CUI DEVICES

Product Change Notice (PCN)

PCN Number: PCN-0381131R-01

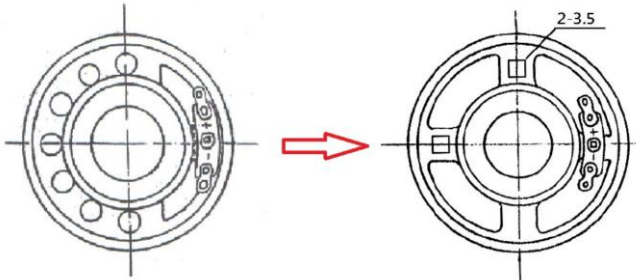
- SPL increased from 80dB to 84dB
- Frame shape has changed (Image Below)

- Tooling plate outdated upgraded
